PROJECT: Panther Medical

CITY OF LAS VEGAS		DATE:
INTER-OFFICE MEMORANDUM		October 15, 2020
TO: Land Development Services Department of Building & Safety		FROM: Jennifer Shinn, P.E.  Flood Control, Engr. Associate Department of Public Works
SUBJECT:	Drainage Study for:	COPIES TO:
	Panther Medical	Panther Hualapai Corner LLC
Cross Streets:	Hualapai Way and Alta Way	Rietz Consulting, Inc.
File Number:	F:\Depot\DSMemos\DS05369A.doc	Bart Anderson, P.E., DevCo
Parcel Number:	138-31-210-004, 009 & 010, 138-31-216-001	
Zoning Action:	20-0027-SDR	
FEMA Flood Zone	YES	NO X
Proposed Storm Drain	YES	NO X

TECHNICAL DRAINAGE STUDY

PANTHER MEDICAL

Worksheet for SECTION I2 100-YR

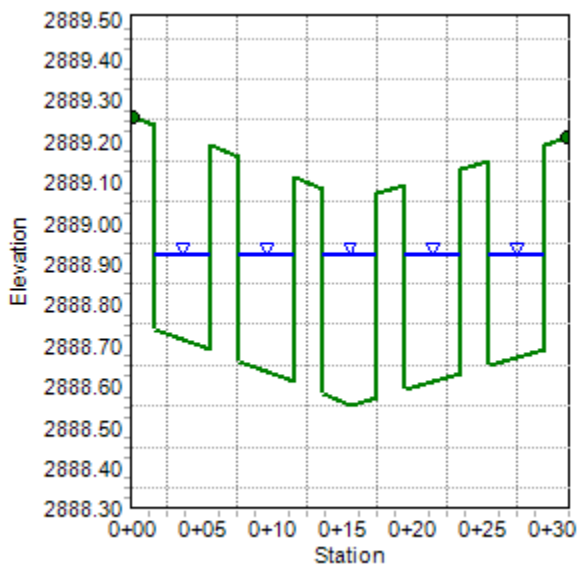
- Provide rip-rap calculations for the I2 rip-rap pad.
- The rip-rap calculations references Eq. 743 from the HCDDM, however it is Eq. 734.
- Sheet C4, C5 and C6:** Several Grading Callout 23s callout two different TW elevations at a single location on the proposed retaining wall. Verify the correct TW elevation.

SHEET
C6
6 OF 8 SHEETS

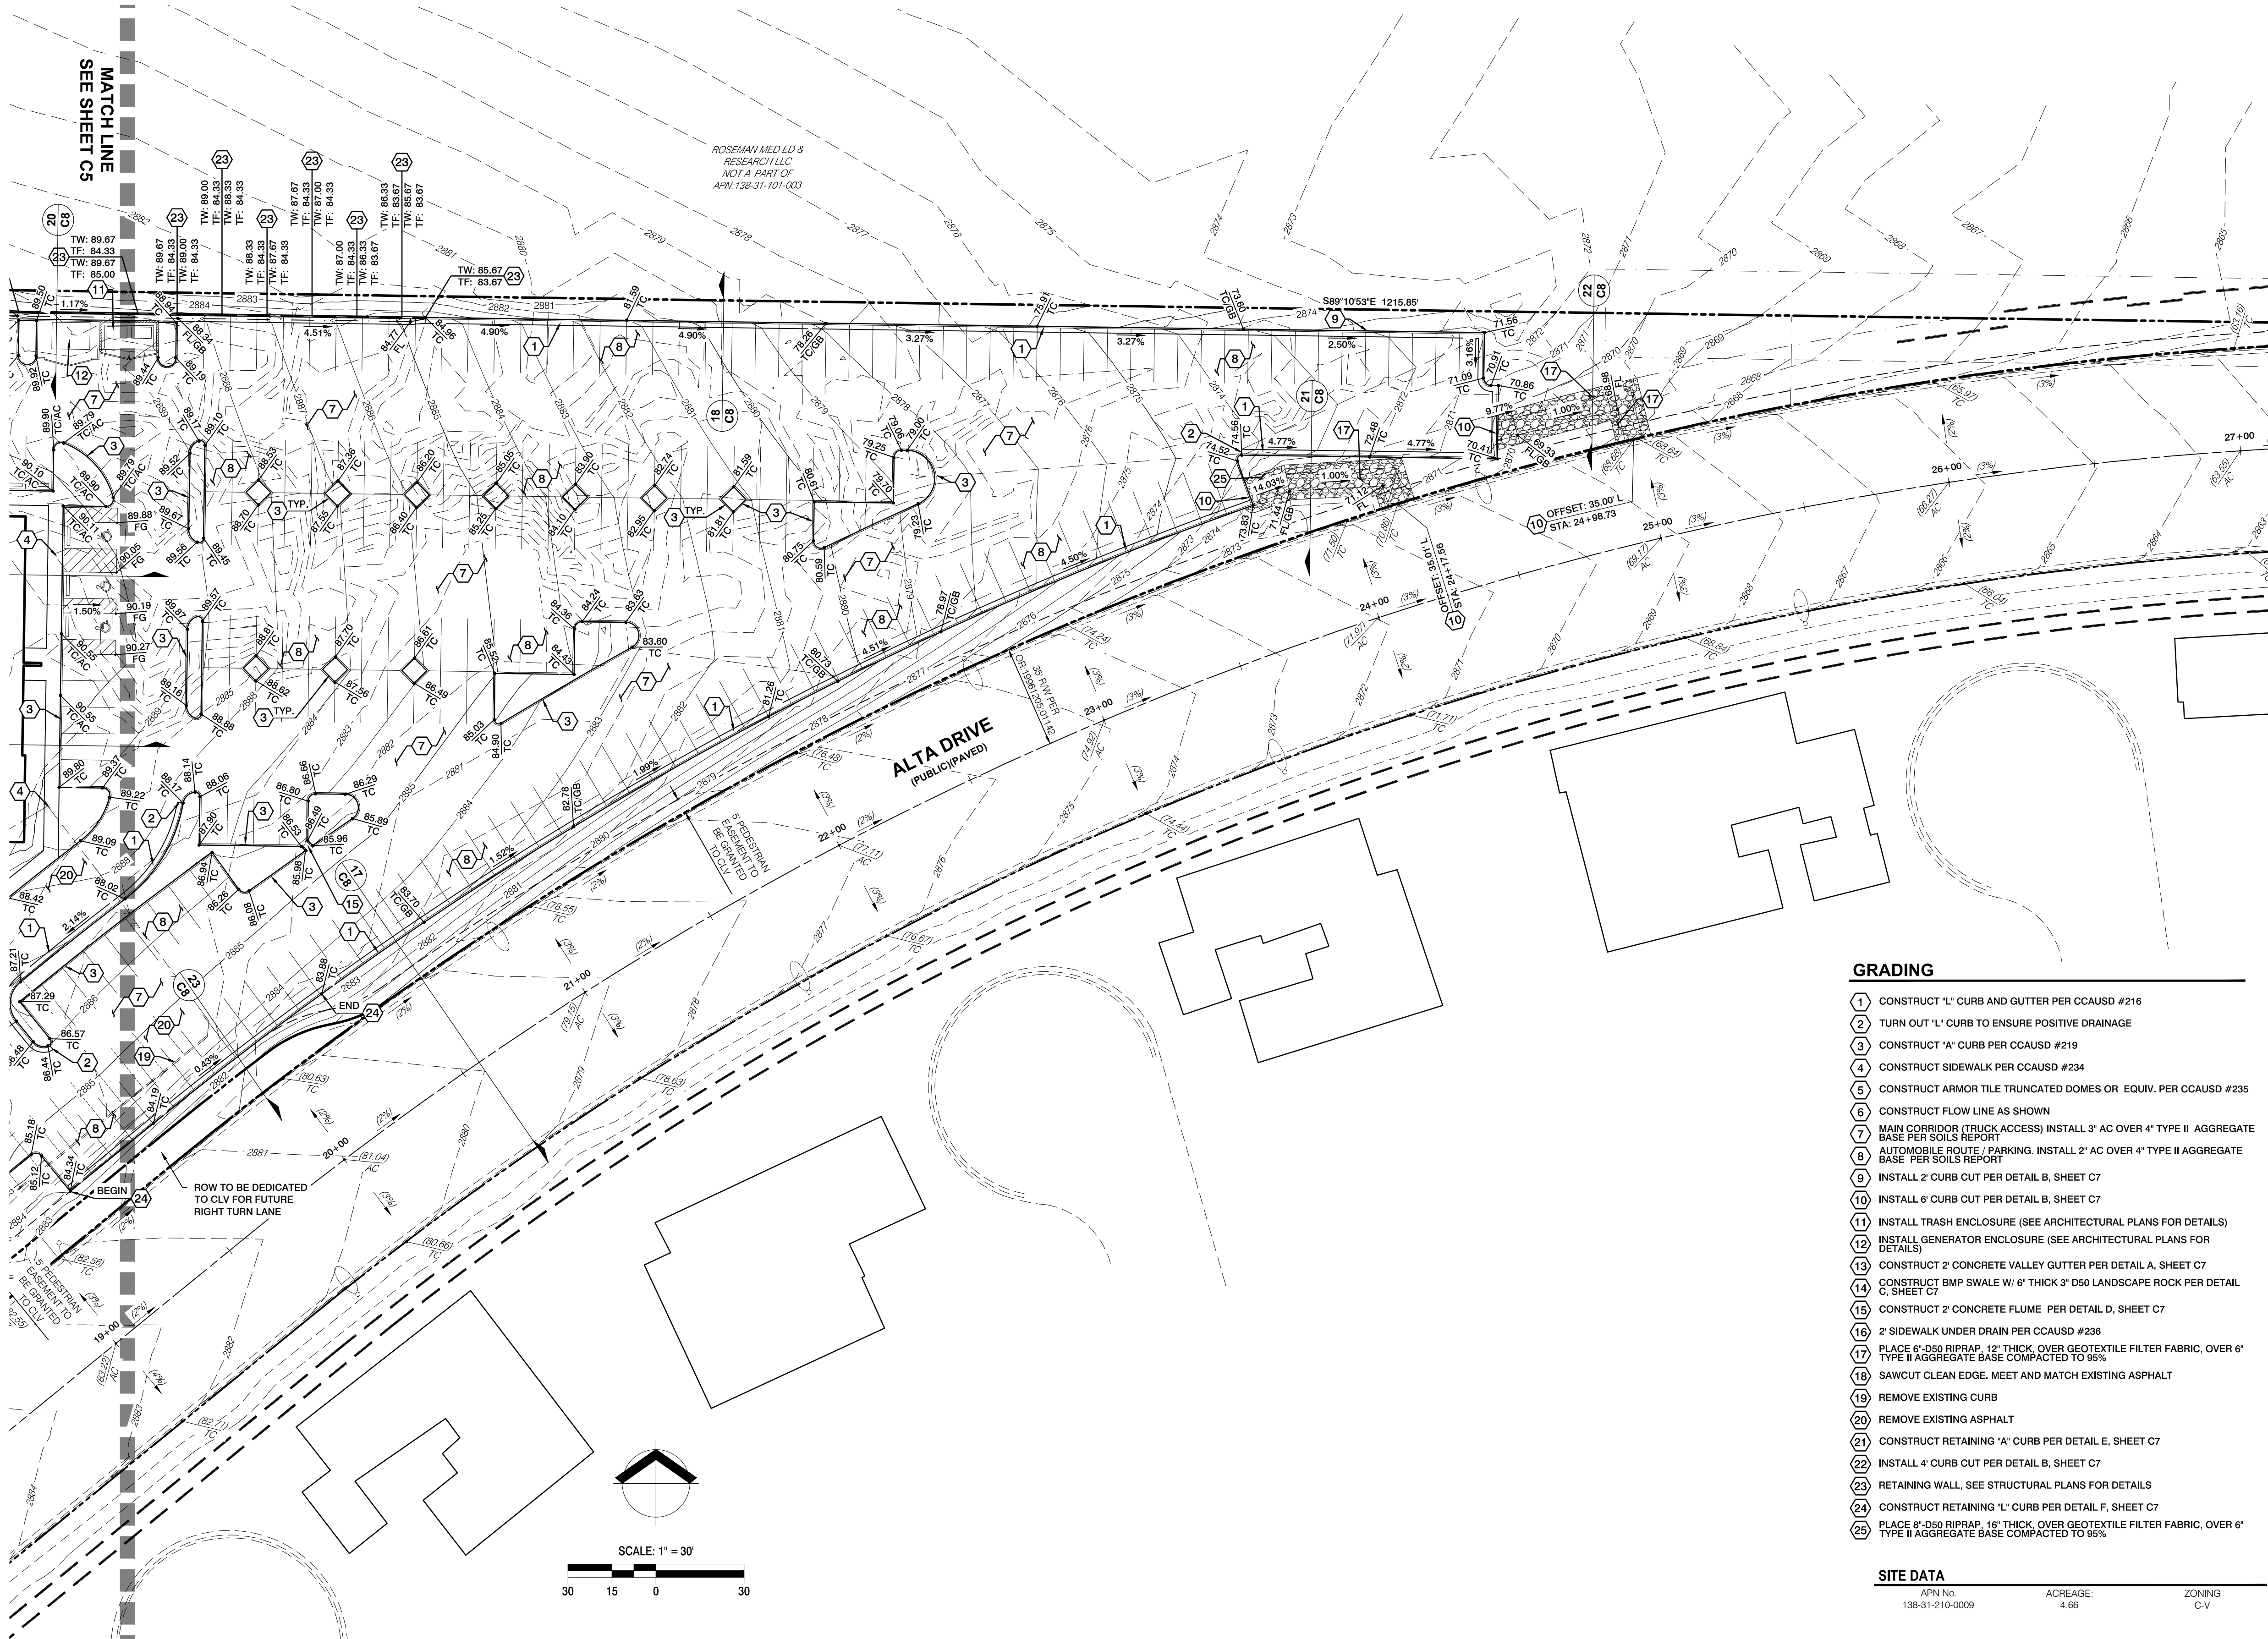
- Sheet C6:** It appears a 2' curb cut (Grading Callout 9) is proposed on the north side of the site just north of the riprap swales. Provide an explanation for the curb cut.
